Groundwater Application Review Summary Form

Application # G- 18848

To: Kristopher Byrd, Well Construction and Compliance Section Manager
From: Joel Jeffery, Well Construction Program Coordinator
Subject: Review of Water Right Application G-18848
Date: September 18, 2019

TO: Water Rights Section Date 09/11/2019
 FROM: Groundwater Section Phillip I. Marcy
 SUBJECT: Application G- 18848 Supersedes review of _____
 Reviewer's Name
 Date of Review(s)

Well Location Map

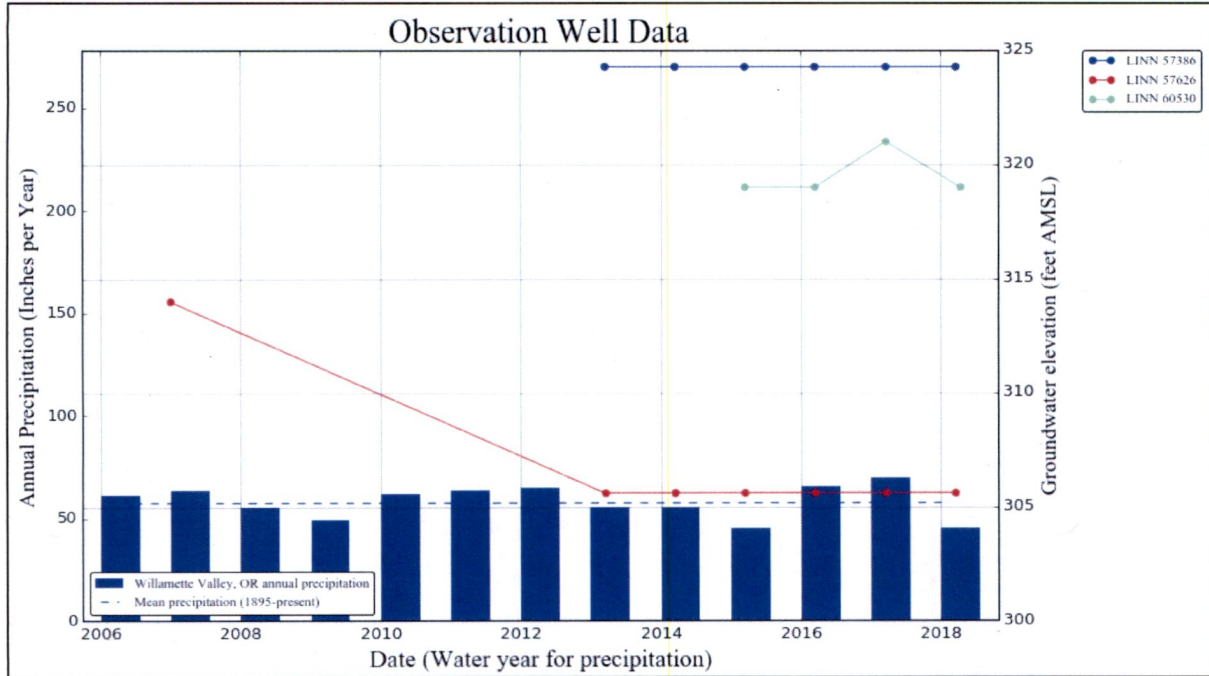
B3. **Groundwater availability remarks:** The nearest senior POA to any of the proposed POAs on this application (LINN 13422, authorized under certificate 43189) is 3,500 feet to the SW of proposed POA 2. Data from nearby pump tests submitted to the department suggest fairly low values for transmissivity (15-30 ft²/day) in the sand and gravel aquifer here. This parameter, in conjunction with fairly sparse distribution of coarse-grained sediments within the alluvial sequence, results in fairly low transmissivity for the local alluvial aquifer. Considering these factors, a time-drawdown calculation based on the full requested rate of 0.2 cfs from proposed POA well 2 to LINN 13422, authorized under Certificate 43189. Resulting values for expected drawdown at the senior water right location after 245 days at the proposed POA 2 location are calculated to be less than one foot. using storativity values typical of confined to semi-confined systems.

Water-Level Trends in Nearby Wells

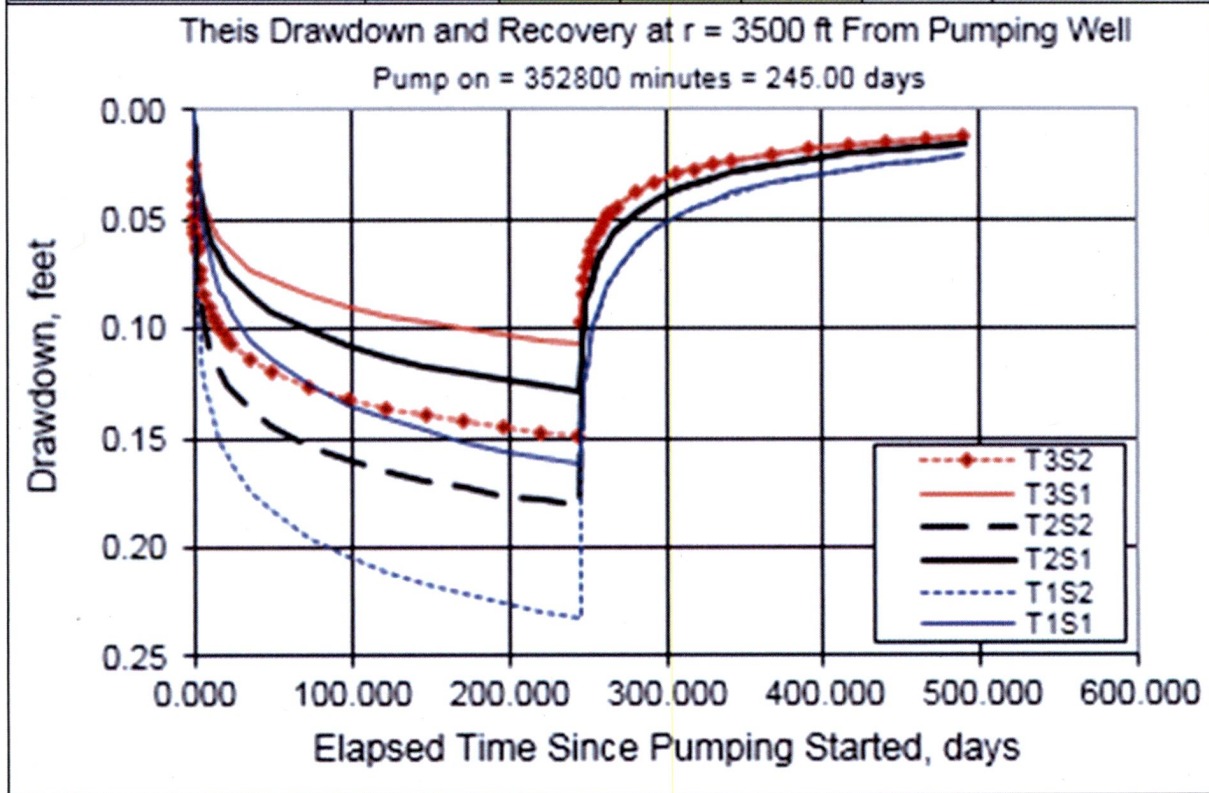
Groundwater level data are limited in this area, but three wells with at least four consecutive annual measurements exist roughly two miles west of the proposed POA well locations. These wells suggest that groundwater levels within the past 5-6 years have been stable (see attached hydrograph).

Top: Group hydrograph for nearest observation wells to proposed POA locations, compared with yearly precipitation data.

Bottom: Input parameters and resulting model output for time-drawdown prediction of impacts of pumping on nearby senior groundwater users.
